Company	Trenz Electronic GmbH
PCN Number	PCN-20250722
Title	TE0950-03 FTDI EEPROM Update
Subject	FTDI EEPROM
Issue Date	2025-07-22

Affected Product
TE0950-03-*

2.1 #1 FTDI EEPROM content: AMD-Licence key

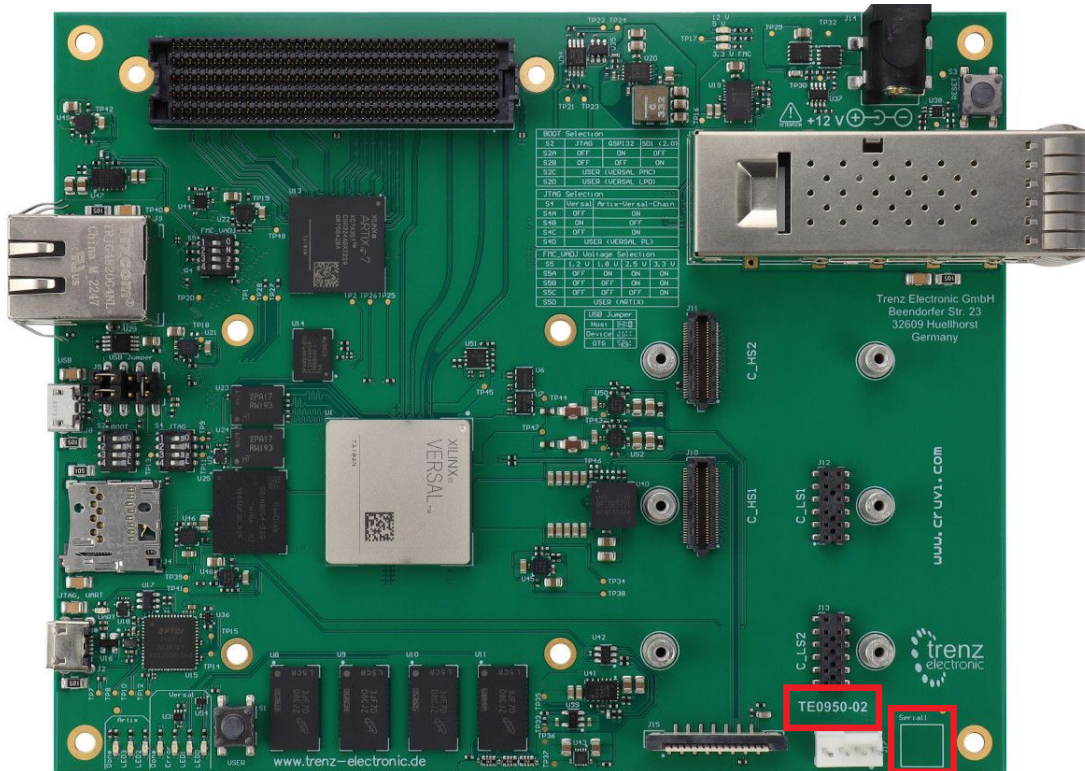
Type: Firmware change

Reason: Change according to FTDI programming method released by AMD with Tool Version 2022.2 and newer (UG980 - Chapter: Programming FTDI Devices for Vivado Hardware Manager Support).

Impact: AMD Licence key is compatible with AMD Tools greater and equal 2017.1 release. Programmer will be identified as Xilinx device with prefix 'TE' ,see [AMD FTDI JTAG Programmer#IdentificationofAMD/TrenzLicence](#)
